Road Safety Audit REPORT

WIS 441 Tri-County Project

Date: Apr 25-26, 2012

Audit Type: Preliminary Stage

Issue 117: Trailblazer location

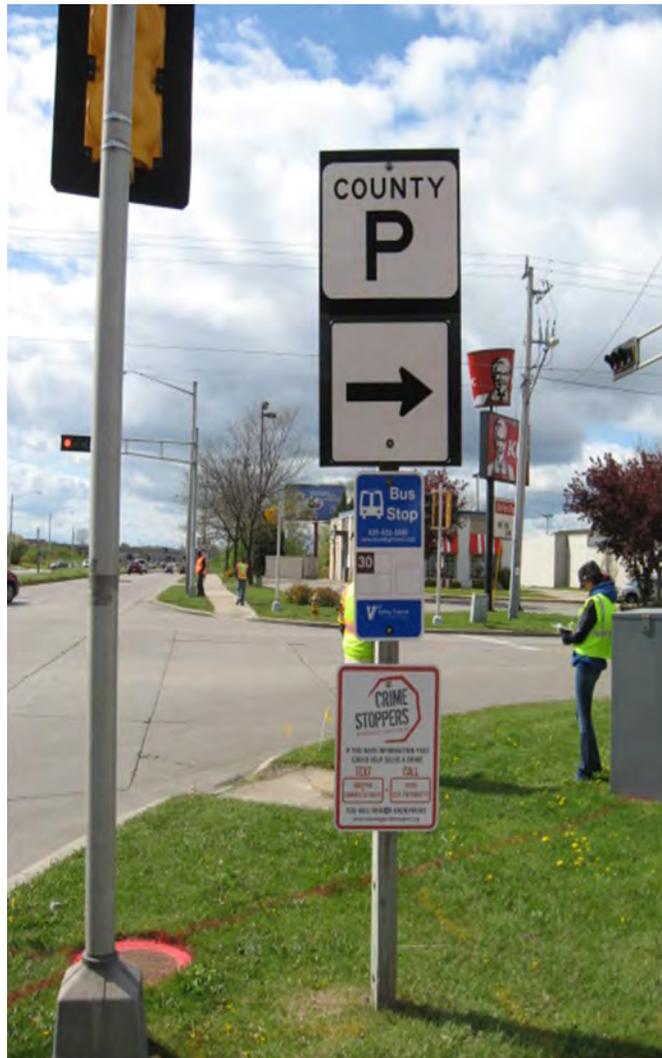
The trailblazers at Midway Road and Appleton Road are located right at the intersection. This does not provide advance notice to the motorist approaching the intersection and allow time to make a lane change prior to reaching the intersection.

Issue 164: No sidewalks or ramps

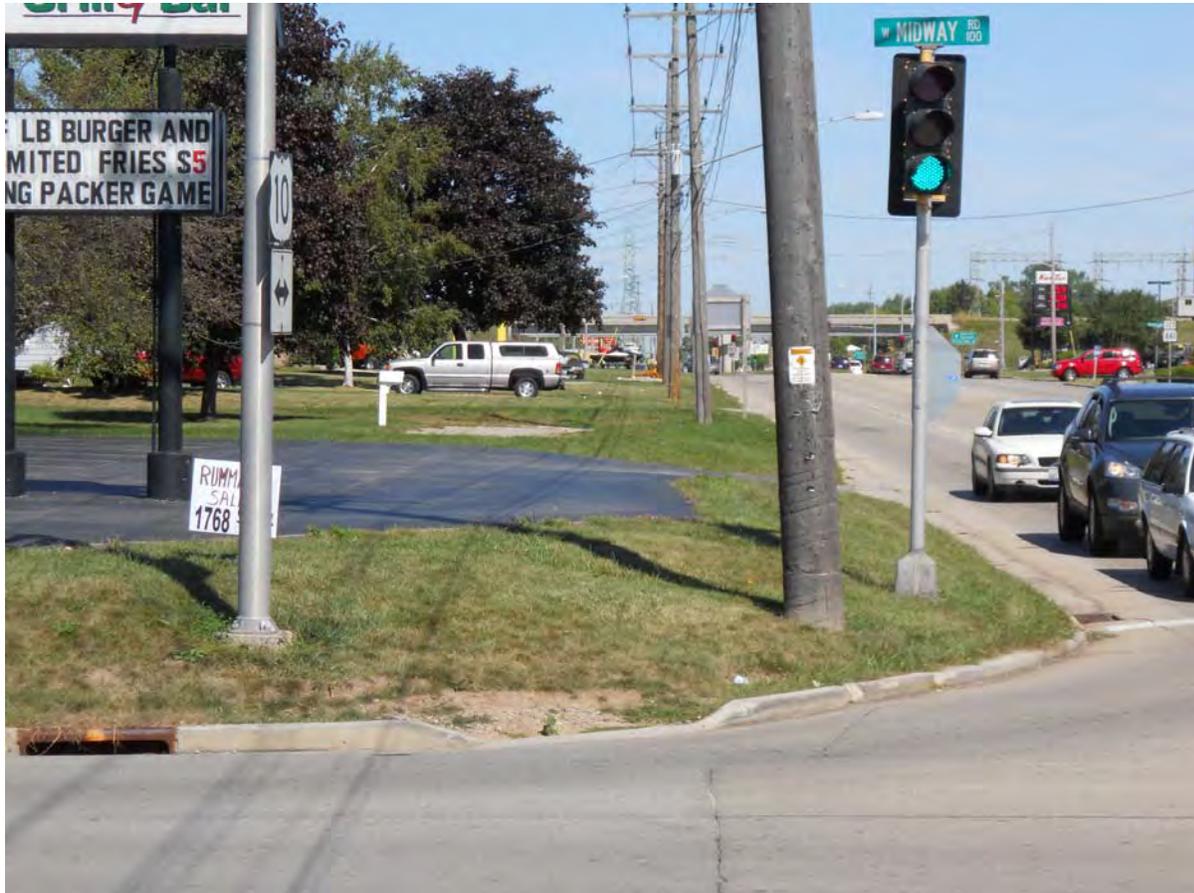
There are no sidewalks and pedestrian ramps in the northwest corner of the intersection of Oneida Street at Midway Road.
